Technical Note

2012:37

Selective review of the hydrogeological aspects of SR-Site

Selective review of the hydrogeological aspects of SR-Site

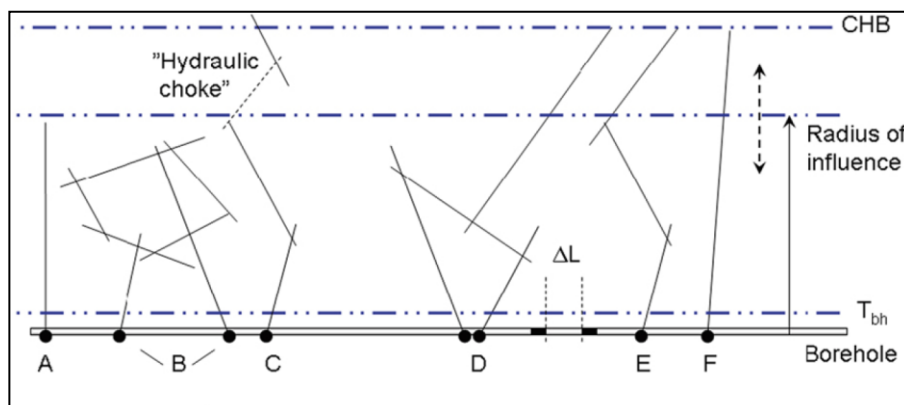
Follin et al., (R-07-48) explain the 'decrease-with value' discrepancy on the grounds that the straddle packer testing is short term and the flow logging is long term. They explain the 'unseen anomalies' in terms of a short term value that declines with time to a value less than the flow-logging threshold. This is the idea of 'hydraulic chokes' that is introduced here in Figure 4.

Figure 6   Comparison of straddle packer and flow test derived values of transmissivity

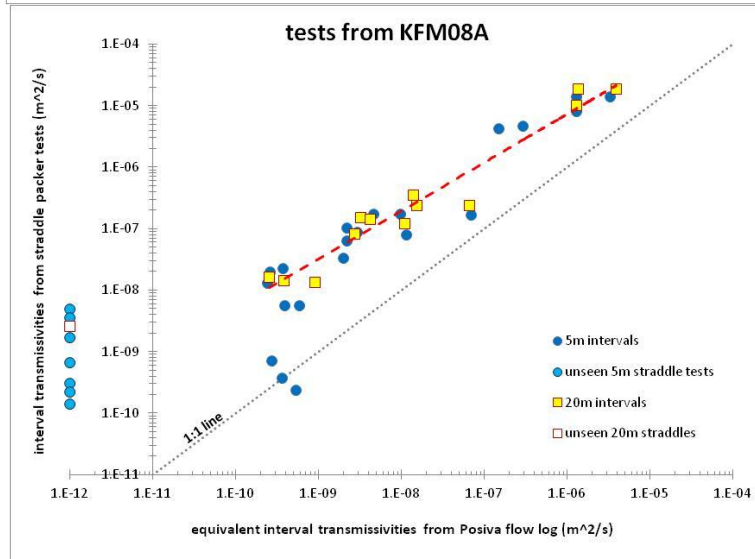
The most extensive set of comparisons between PFL-f and PSS data is contained in Follin et al., (Sections 4.3 & 4.5of R-07-48) where (almost) all KFM boreholes between 1 and 8 where both methods have been used are cross-plotted. I include copies of three (KFM6A, 4A and 8A) in Figure 6. They are re-plotted in order to include a trend line and improve clarity. Each of them shows roughly similar behaviour of increasing divergence as transmissivity decreases with the PFL-f method recording the lower value.

The other notable feature of the plots is the number of straddle packer measured flowing intervals that are not seen by the PFL-f method (values are placed to the left of the Y-axis at an arbitrary value of PFL-f transmissivity). Values from KFM04A are particularly noteworthy because some 'high' values of PSS transmissivity are not 'seen' by the flow logging method. However it should be borne in mind that there are only 3 twenty metre tests and 4 five metre tests below -400m elevation in FFM01 in borehole KFM04A. In other words, most of these considerations do not concern 'background rock' in the repository zone.

I am sceptical of this argument because the decline of inflow with time should be proportional to transmissivity so all inflows of the same value should be affected equally. On the other hand, the 'decrease-with-value' deviation seems to lead to greater spread with decreasing transmissivity. As far as the choke explanation is concerned, KFM04A exhibits a three decade spread of 'unseen anomalies'. The upper values could not be expected to decline gradually to less than the threshold and a 'barrier boundary' would need to act rather suddenly. Also high transmissivity means a large region of influence of a test so the immediate fracture cluster (compartment) would have to have large physical dimensions.
